World Forum for Harmonization of Vehicle Regulations

Working Party on Lighting and Light Signalling (GRE)

Proposal for Supplement 9 to the 01 series of amendments to Regulation No. 70 (Rear marking plates for heavy and long vehicles)

Submitted by the expert from Germany*

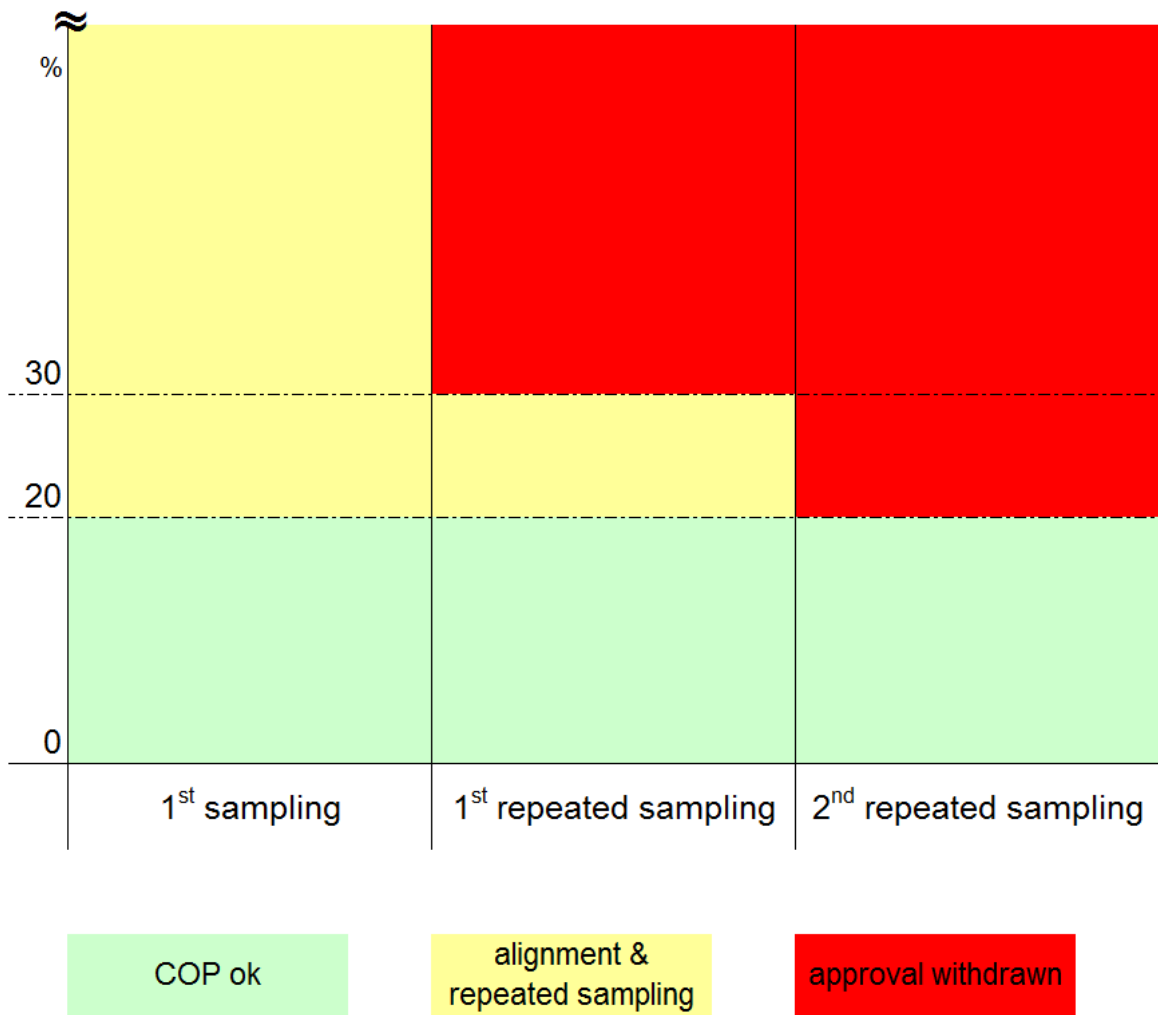
6. CoP is now described in a clear structured stepwise process (with limited steps), which gives the manufacturer the chance in the first step - in the case of deviations of more than 20 per cent - to align his production process. Also, the CoP process can be completed earlier when the first two samples are in the full specifications.

7. The proposal details the "third step" which defines the condition where the approval shall be withdrawn, when after the second repetition of this process the manufacturer was not in the position to "align" his production process in the correct way.

8. The attached drawing shall demonstrate this stepwise process.
